Re: Invitation to comment - Winchelsea Island Manganese Mine Project draft Environmental Impact Statement

Submission on the draft Environmental Impact Statement

Winchelsea Mining Pty Ltd – Winchelsea Island Manganese Mine Project

Government authority: Department of Environment, Parks and Water Security – Flora and Fauna Division

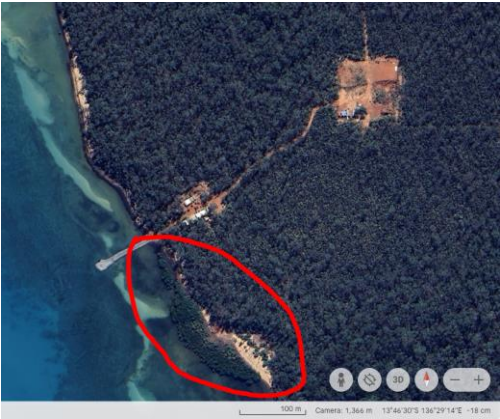
<p>impacts and risks</p>		<p>The draft EIS appears to rely on very few weather and hydrological data inputs at the local scale. Sampling for currents in the project area would have also benefited from longer deployment and more strategic placement of loggers in the local and regional study area.</p> <p>Understanding the local conditions in the project area is vital for informing an assessment of the potential impact of a proposal and whether the hydrological model is accurate for informing sediment transport in the area. The model appears to be simplistic and needs to include atmospheric and wind conditions. It is also recommended that the model include seasonal water inflows and take into account extreme weather events that are likely to occur over the life of the proposal.</p>
<p>Draft EIS Section 9.7.2.1 Alteration to Coastal Processes</p>		<p>The draft EIS states that: “Potential impacts to coastal processes from introduction of invasive marine species and coastal sedimentation from land erosion are considered sufficiently insignificant that these sources of potential impact are not discussed in detail below.”</p> <p>The Flora and Fauna Division notes that these claims are unsubstantiated. The proposed clearing of vegetation and excavation of pits may result in severe erosion (in the absence of appropriate control measures) during significant rainfall. This allows potential for significant sediment inputs into the marine environment, which have not been considered in hydrodynamic modelling. Inputs from terrestrial water courses (even if seasonal) should be included in any modelling and accounted for in terms of potential impact.</p> <p>Section 9.7.2.1 of the draft EIS states that: “These estimates indicate that the facility will interrupt relatively small existing rates of bed load transport under ambient conditions (<50m³/year southward and <15m³/year northward), with higher rates of southward transport possible during a single significant tropical cyclone event (~100-500m³ depending on storm intensity, pathway and coincident tides) (SeaShore Engineering, 2023).”</p> <p>The Flora and Fauna Division recommends that the proponent explore the fate of interrupted sediment further using appropriate modelling, particularly when affected by severe weather events.</p>

<p>The draft EIS states that: “...of sedimentation occurring in discrete areas, it is anticipated that navigation channel management will typically involve bed levelling every 5-10 years and potentially one maintenance dredging campaign over the life of the project (SeaShore Engineering, 2023).”</p> <p>It is unclear what this estimate is based on and what the implications of recurrent dredging and ‘channel management’ would be on a range of sediment types and movement. Information on the impact of recurrent dredging and ‘channel management’ on coastal processes and marine biota should be provided in the Supplement.</p>
<p>Hydrological and Sediment Transport Modelling Appendix S</p>		<p>The draft EIS states that: “The sediment mass released to the water column during dredging and disposal is a function of the total volume (mass) of sediments dredged and disposed, as well as the dredging and disposal techniques. For the purposes of this assessment, the dredge volume of the channel leading to the wharf is conservatively assumed to be 150,000m³.”</p> <p>It is unclear how these calculations were derived. To ensure that the correct dredging volume can be assessed, it is recommended that information about how these volumes were calculated be provided in the Supplement.</p> <p>The hydrological and sediment transport model appears to be simplistic across regional and local scales. Poor ‘fitting’ is potentially the underlying cause for an “inadequate reasonable representation”, particularly concerning the boundary conditions. It is recommended that the model include atmospheric and wind conditions, as well as the influence of seasonal water inflows. The model also lacks the inclusion of extreme weather events and how these would influence the site under pre and post- development scenarios.</p> <p>The grid cell size used for the modelling appears to be too large and, due to poor representation of the conditions onsite, renders the model uninformative. The general minimum size used is 25m, rather than 50m as per the draft EIS. For the purpose of assessing impacts on benthic habitats, the Flora and Fauna Division recommends that a grid cell size of 5m or less be used. This is important, as areas of higher value can be localised and not specifically identified using a grid cell of 50m.</p>

<p>The assessment of water level from the model (RMSE (m)) appears to exceed the recommended +/- 0.1m and vastly exceeds the +/- 15m (Appendix S Table 5-2 p.51), indicating poor model performance (see Williams 2017).</p> <p>Modelling of currents appears to have some exceedance of the recommended 50% Scatter Index (SI) (see Appendix S, Table 5-3, p.58) and appears to have some qualitative issues with the M2 phase (Appendix S, Figure 5-17 and 5-18, p.57). The fitting for currents appears to be adequate and consistent with Grote <i>et al.</i> 2016).</p> <p>Grote , M. Mazurek, N. Grabsch, C. Zelinger, J. Le Floch, S. Wharendort, D. Hofer, T. (2016) Dry bulk cargo shipping – an overlooked threat to the marine environment? <i>Marine Pollution Bulletin.</i> 110(1): 511-519.</p> <p>Williams, J. J. (2017) Guidance on setup, calibration and validation of hydrodynamic, wave, and sediment models for shelf seas and estuaries. <i>Advances in Civil Engineering</i>, 2017 (3-4): 1-25.</p>
